SUBJECT: Provides info requested by NRC during 971219 telcon re containment construction hatch removal/replacement.

RE: St. Lucie Unit 1  
Docket No. 50-335  
NRC Requested Information  
Containment Construction Hatch Removal/Replacement

Figure 1

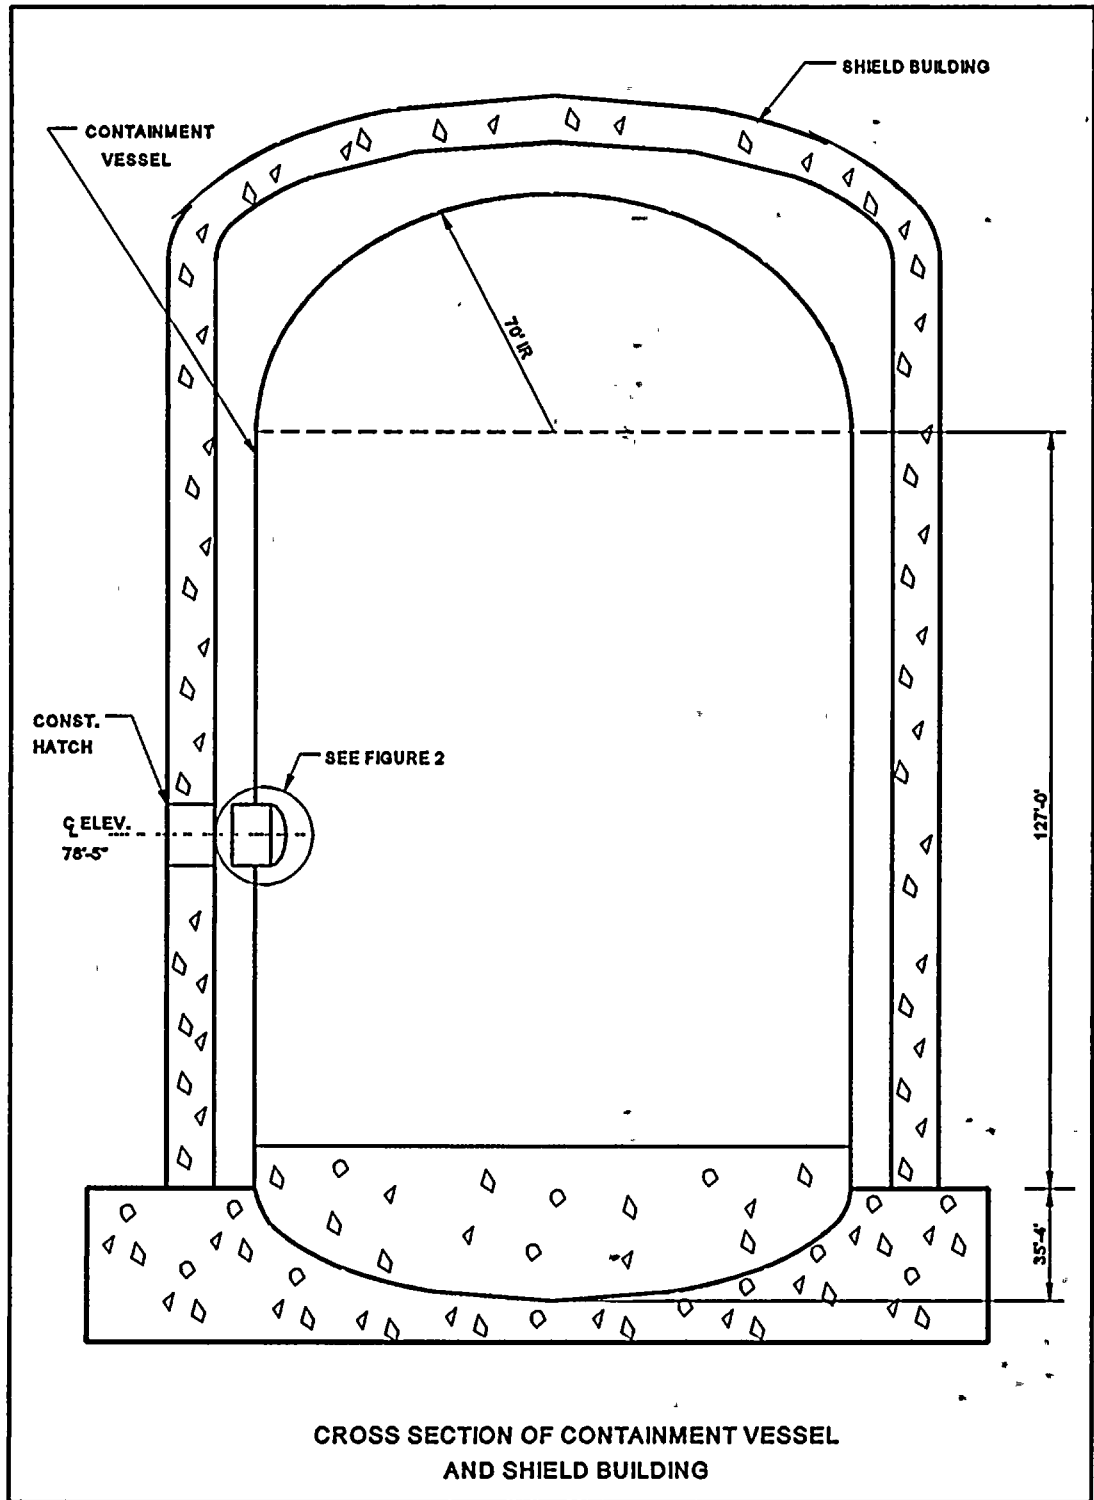
**What fit up and weld configuration inspections were conducted to ensure that the weld joint was in accordance with the existing design, and ASME Code requirements?**

As described in FPL letter L-97-287 dated November 7, 1997, the St. Lucie Unit 1 containment is a free standing cylindrical carbon steel vessel with a hemispherical dome (Figure 1). The construction hatch consists of a twenty-eight foot (inside diameter) reinforced penetration in the steel containment shell. An ellipsoidal cap is butt welded to the penetration barrel on the inside of the containment. To open the construction hatch, the existing full penetration butt weld between the penetration barrel and the hatch cover was thermally cut.

To reinstall the cap, new weld surfaces were prepared by grinding on the cap and the penetration barrel. As part of the work package instructions, coatings were removed, where required and the surfaces were visually inspected. The inspection included dimensional checks, profile, fit up (high/low), and root gap, and found to be within the criteria specified in ASME Section III and the FPL Weld Control Program. In addition, a magnetic particle surface examination (MT) was performed on both surfaces prior to welding in accordance with ASME Section III.

After completion of the root pass and the welding on the inside of the containment (from the outside diameter), the root was back gouged and visual (VT) and magnetic particle (MT) examinations were performed prior to final welding. Upon completion of the welding outside of the containment (from the inside diameter), final visual (VT), magnetic particle (MT), and radiography (RT) examinations will be performed.

Figure 2

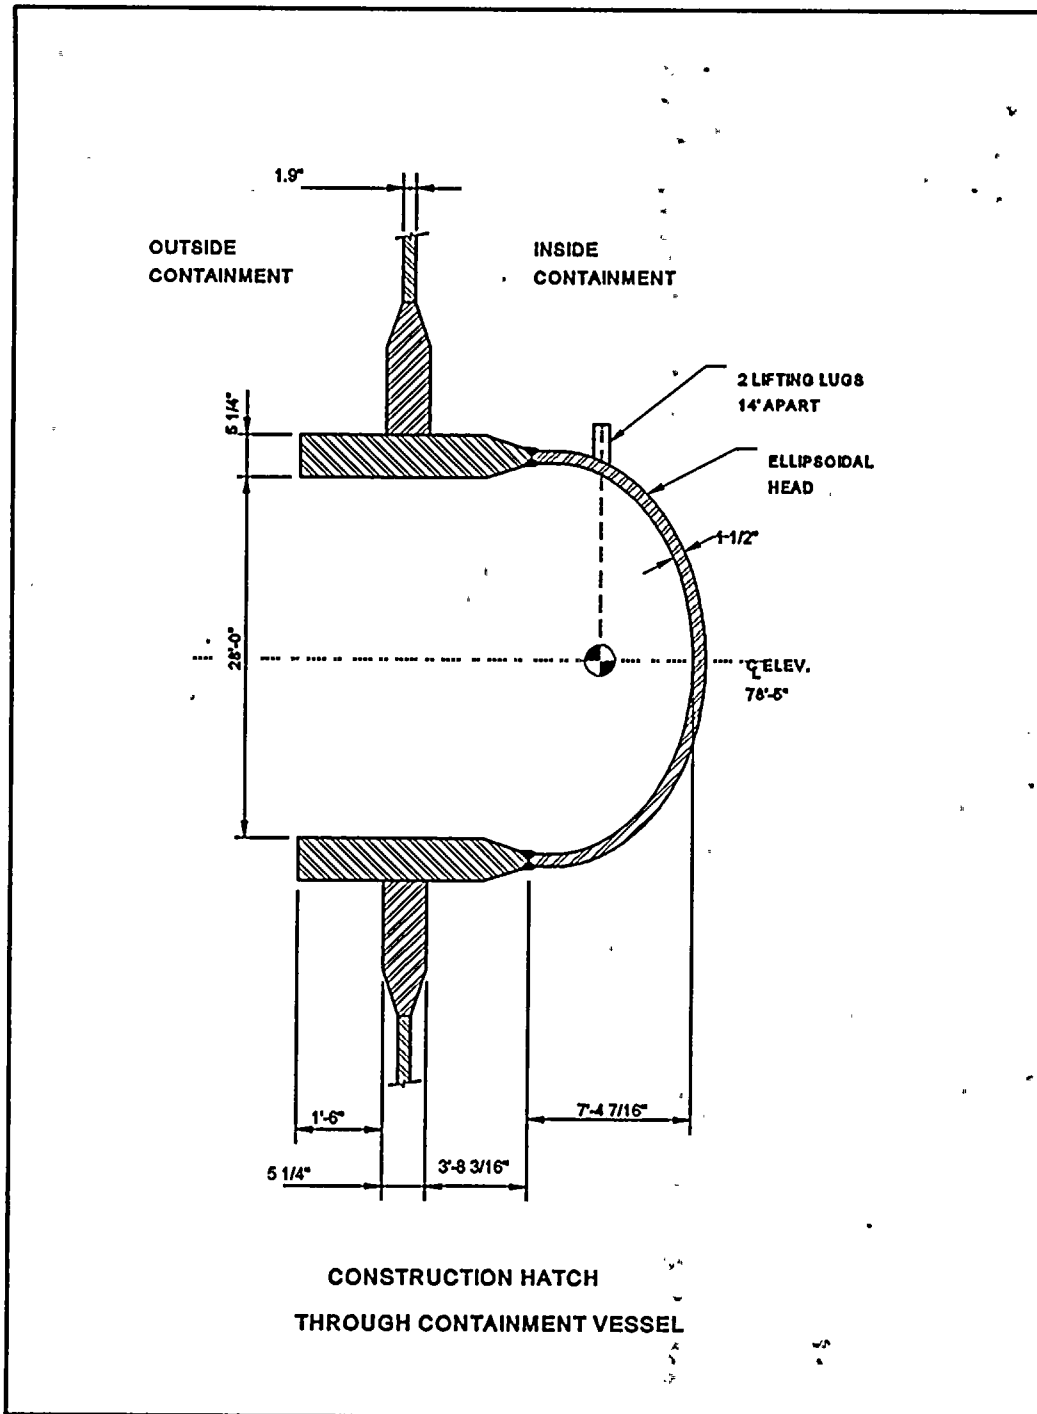
**What construction methods were used to temporarily support the construction hatch cover during cutting, machining, and welding?**

To remove the hatch cover, the butt weld between the hatch cover and the penetration barrel was thermally cut for most of the circumference, leaving 4 tabs. The length of the cut tabs was determined by calculation to not over stress the penetration barrel or hatch cover material, with an adequate factor of safety. The hatch cover was then rigged using

the existing lifting lugs, a spreader beam, and the containment polar crane. The lifting lugs were installed during original construction and are located directly above the center of gravity of the ellipsoidal hatch cover. (Figure 2)

After installing the rigging and dunnage underneath the hatch cover, and shimming the gap to prevent any damage, the four support cut tabs were thermally cut. The hatch cover was then moved to, and suspended from, its support brackets on the containment wall, which were also installed during the original construction of St. Lucie Unit 1.

Upon completion of the steam generator replacement activities, the hatch cover was rigged using the spreader beam and the polar crane and moved to the penetration barrel. Five temporary alignment lugs were utilized to ensure proper alignment and wooden wedges were used to establish the proper root gap. Once the proper alignment was inspected, the root tacks (approximately 1/2 inch deep by 12 inches long at 90 degree intervals) were welded. The rigging remained in place until four root tacks were completed. The size of the root tacks was sufficient to withstand the loading with no adverse affect on the existing base metal. The rigging was then removed and the final weld out completed.
